PRELIMINARY SITE PLAN
BISHOP LAKE RD. SITE
Cobb County, Georgia
St. Clair Holdings, Inc.

PETITION NO: Z-116

ZONING COMMENTS:

STAFF RECOMMENDATIONS

L-001
Sheet Number

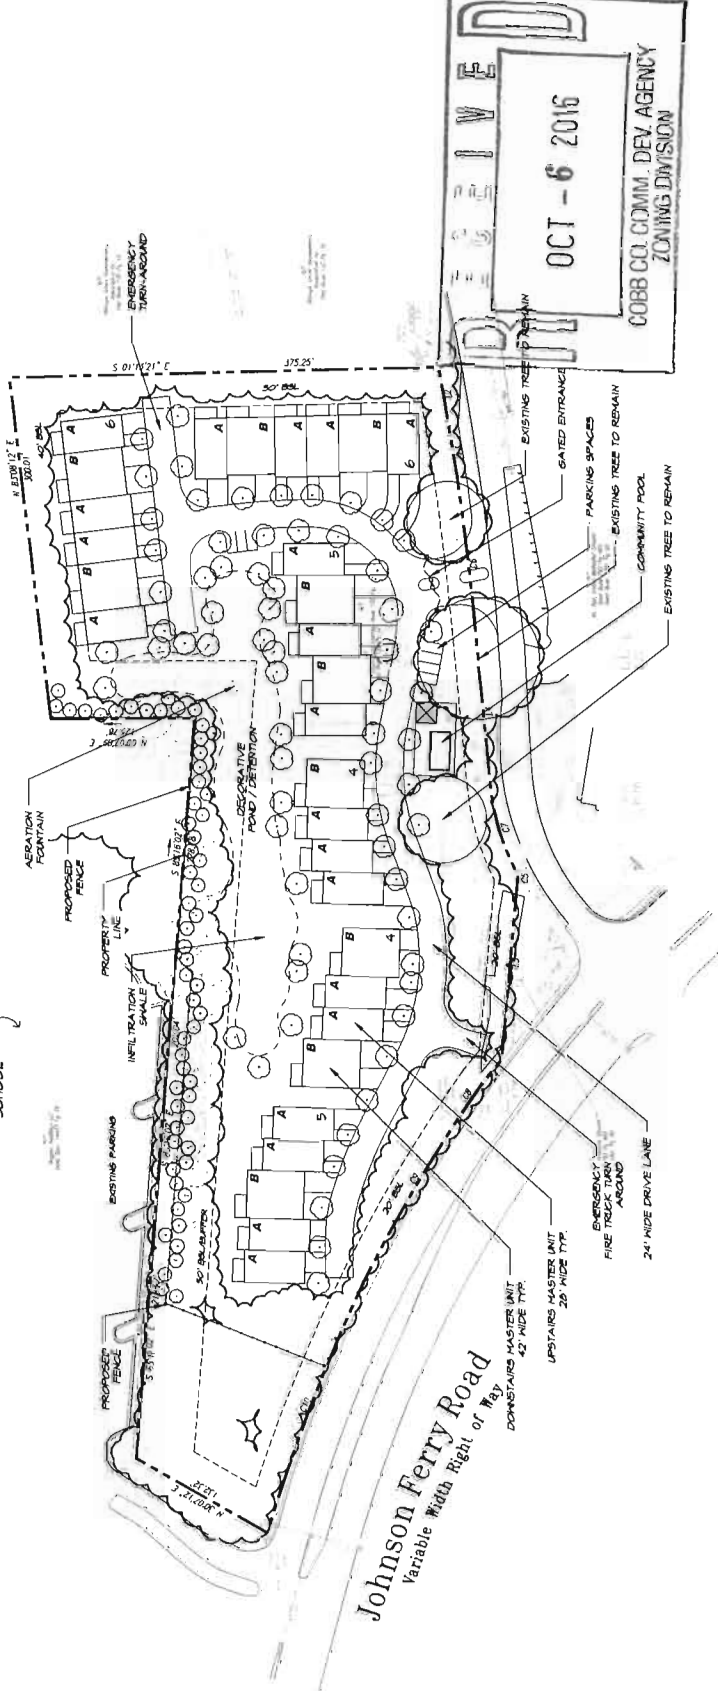
This project must comply with the Cobb County Tree Ordinance. The three existing trees shown as to remain will not receive Tree Ordinance density credit if there is any disturbance within their critical rootzones (CRZ). In addition, Tree Ordinance mitigation will be required if there is any disturbance within their CRZ and they meet the specimen tree criteria as per the Cobb County Tree Ordinance.

If a landscape buffer is required along the NE property line, then it must be fully vegetated across their entire width, and not include any deck/patio encroachments. The rear walls of the units along the NE property line are depicted as being congruent with the 40' building setback line, with no buffer being shown. For safety, security, and maintenance purposes, there must be a physical separation between the rear walls of these units and any required buffer.

- No Stormwater controls shown _____
- Copy of survey is not current – Additional comments may be forthcoming when current site conditions are exposed.
- No site improvements showing on exhibit.
